**Beyond Hello Dispensary  
12140 Springfield Pike  
Concept Plan  
Application PC #20250684  
June 6, 2025**

**BEYOND / HELLO- 12140 SPRINGFIELD PIKE**

**PLAN REVIEW PERMIT #20250684**

**PLANNING COMMISSION  
ENGINEERING REVIEW**

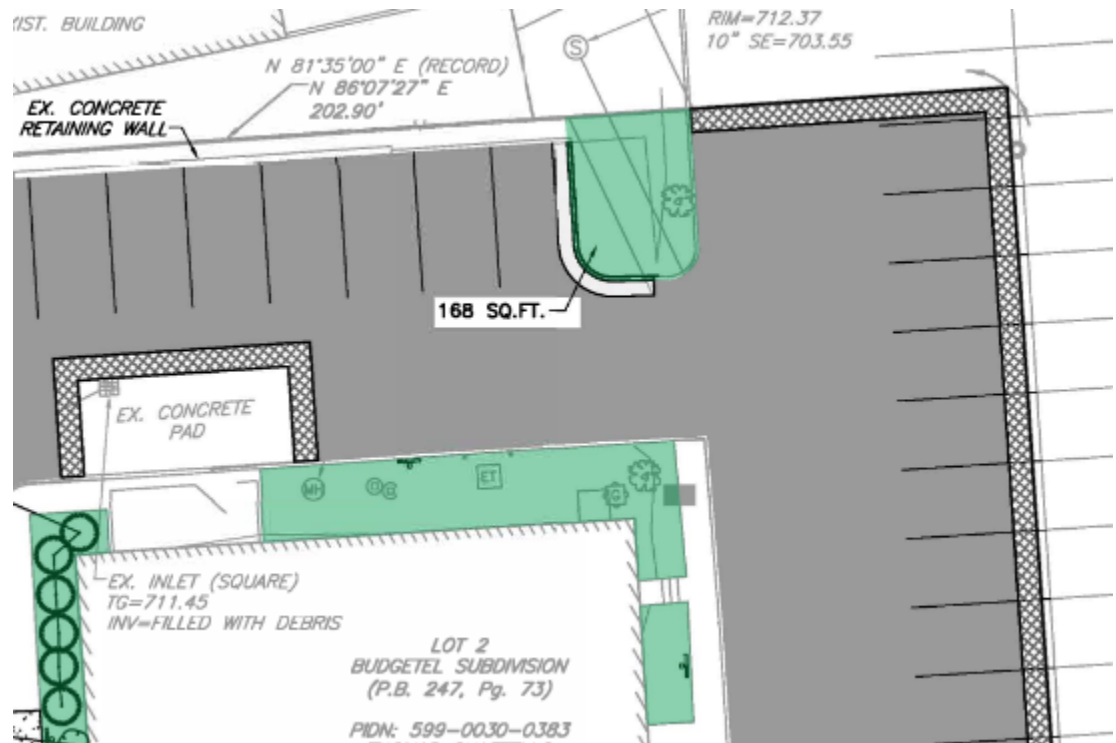
The requirements for the 223' of parking bufferyard are 9 small trees (small trees because of overhead utilities) and 75 shrubs. Two trees (from the interior island plantings can be credited towards the bufferyard) and 38 shrubs are provided, therefore, an additional 7 trees and 37 shrubs are required.

The requirements for the 170' of parking bufferyard are 5 canopy trees and 57 shrubs. There are 0 trees and 11 shrubs provided. Existing development conditions do not make it feasible to install additional plant material because of the existing edge of pavement and existing concrete retaining wall, all proposed to remain. A variance would be required for this requirement.

**PROPOSED ELEVATION - SOUTH**

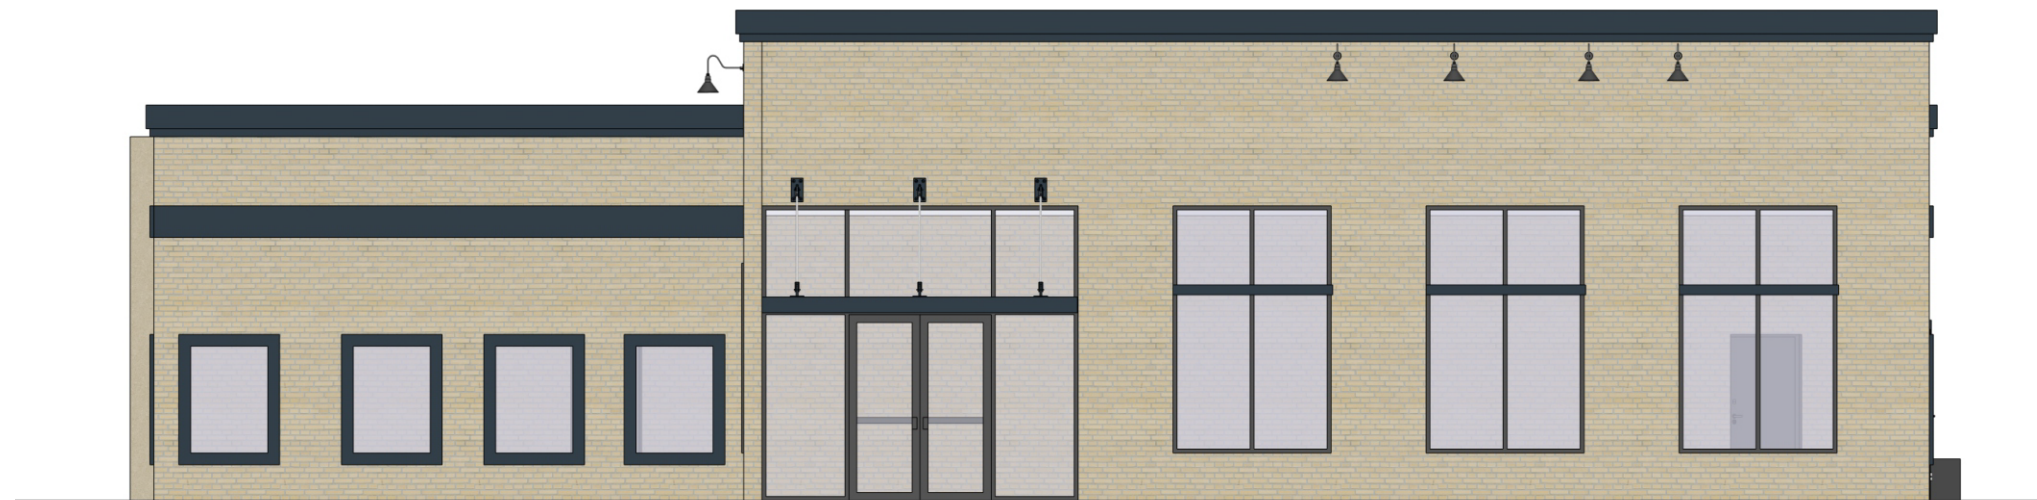
4. **Signage**
  - a. The applicant is proposing two wall signs – one on the southern façade and one on the western façade. Since this property is not a corner lot, only one wall sign is permitted. The proposed wall sign is of an appropriate size and design per Section 153.459(C)(2), but is only permitted on the façade facing the public right-of-way (western façade). The applicant will need to submit a new wall sign plan that is consistent with the zoning regulations.

4. Show how any new mechanical units or similar facilities will be screened per the requirements of Section 153.404(D).
5. The sign plan shall be revised to conform to the regulations of Section 153.459.
6. Revise the landscape plan per the staff's comments and the requirements in Section 153.404.

LANDSCAPE PLAN	
DATE:	YOR
DRAWN BY:	REL
CHECKED BY:	361-052
PROJECT NO:	BMB
APPROVED BY:	
DRAWING NO.:	<b>C700</b>

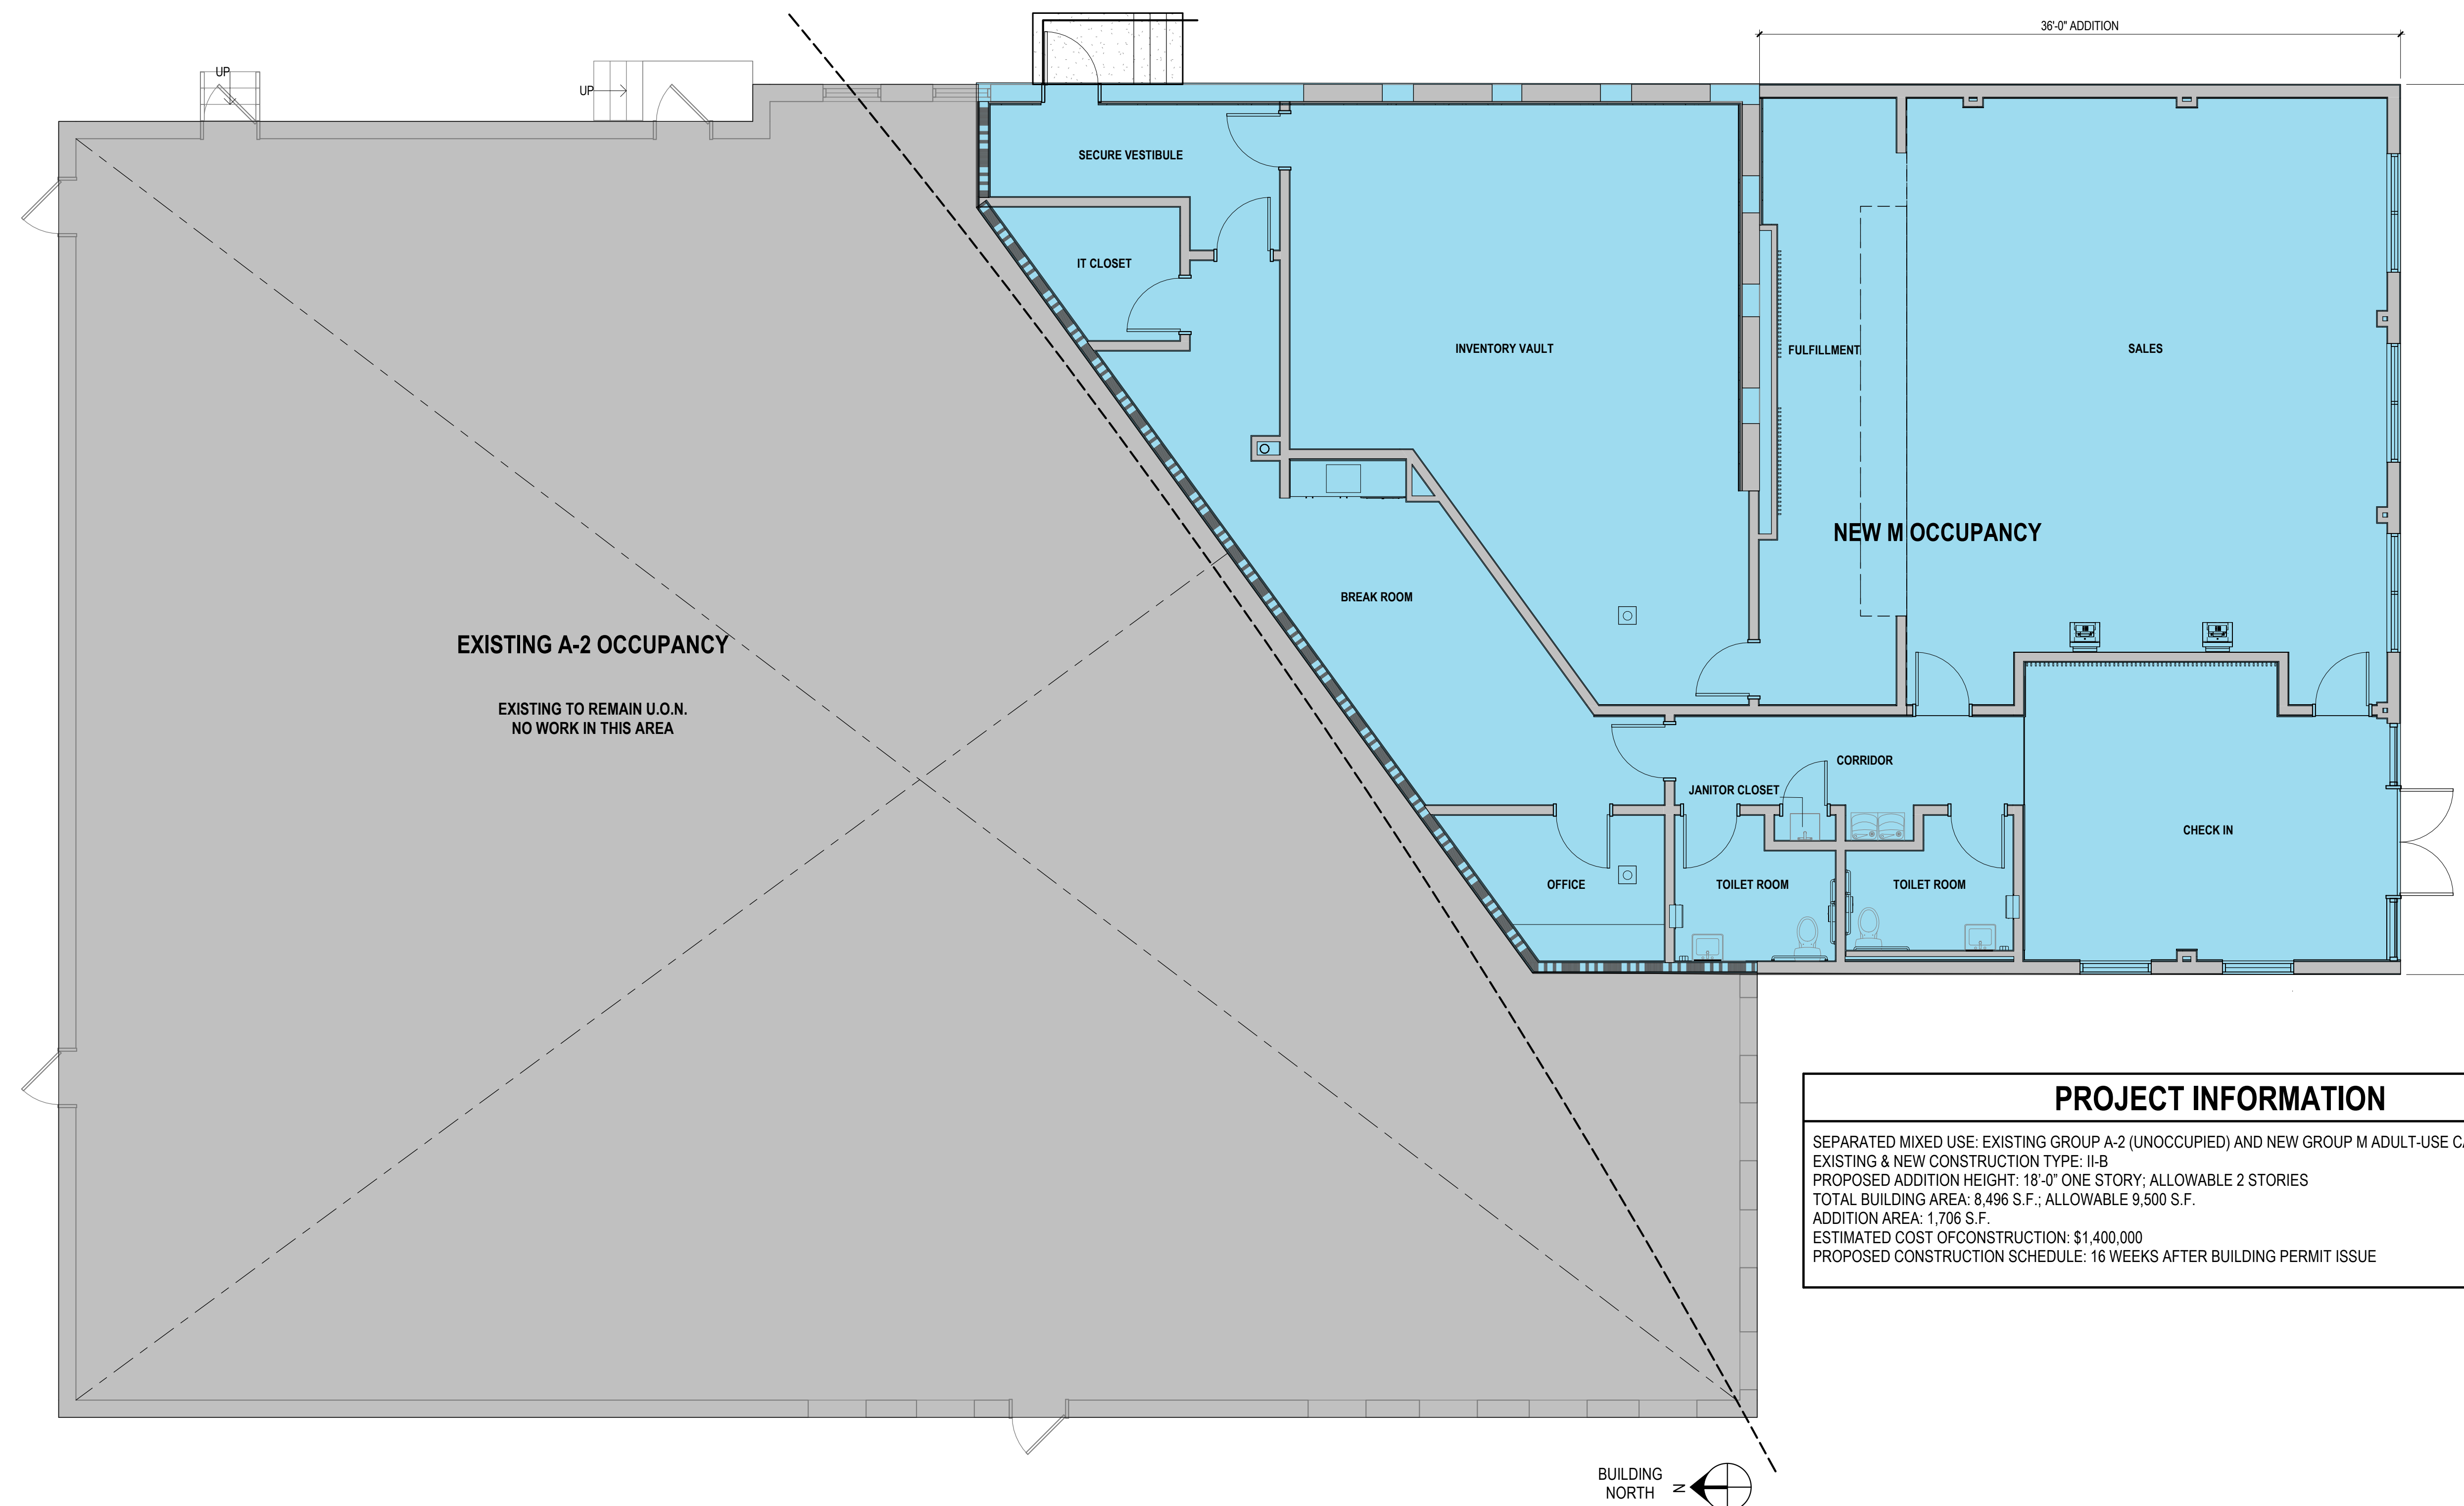
9. **Landscaping**
  - a. Street tree plantings are required for the Corridor Review District.
  - b. Landscape requirements must be documented on the Landscape Plan, identifying the required and proposed landscaping improvements.

- c. The sizes of the existing trees must be indicated on the site plan. The existing trees that are remaining must be labeled "DO NOT DISTURB". Install tree protection during construction.

The Applicant appears to be incorporating the existing trees. However, if trees are removed, the Applicant must provide a summary of the caliper inches of trees that are removed with redevelopment/construction. Tree removal and replacement must be identified per caliper inches removed and replaced. Tree removal for redeveloped sites is one inch replacement for each one inch removed per Section 156.09.
  - d. Bufferyards are required for parking that is adjacent to a right-of way (public street), private street, or adjacent use (non-residential use) per Section 153. 404 (G)(1), Table 404-1. Bufferyard requirements for parking or access drives adjacent to right-of- way, access drives, or adjacent non-residential use are 1 canopy tree per 35' (or 1 small/ornamental tree per 25') and 1 shrub per 3'.

The requirements for 262' of parking bufferyard are 8 canopy trees and 88 shrubs. There are 0 trees and 0 shrubs provided. Existing site development conditions do not make it feasible to install plant material because of existing edge of pavement is proposed to remain. A variance would be required for this requirement.

The requirements for 125' of parking bufferyard are 4 canopy trees and 42 shrubs. Two trees and 17 shrubs are provided. An additional 2 trees and 25 shrubs must be added.

- e. Interior landscape areas are required for the parking area at 5 sq. ft. for each 100sq. ft.
- f. Interior landscape islands must meet the minimum plant material requirements (1 tree and 4 shrubs), per Section 153.404(C)(2). All proposed islands do not meet this requirement.
- g. Service structures must be screened a minimum of 1' higher than the service structure per Section 153.404(D). Provide information on height of existing enclosure.
- h. Add parking blocks to minimize encroachment on sidewalks and where plant material should be protected from vehicles pulling into parking spaces.
- i. Clearly identify ground treatment in areas not hatched for seed or sod. Landscape plan must clearly show limits of mulch beds.
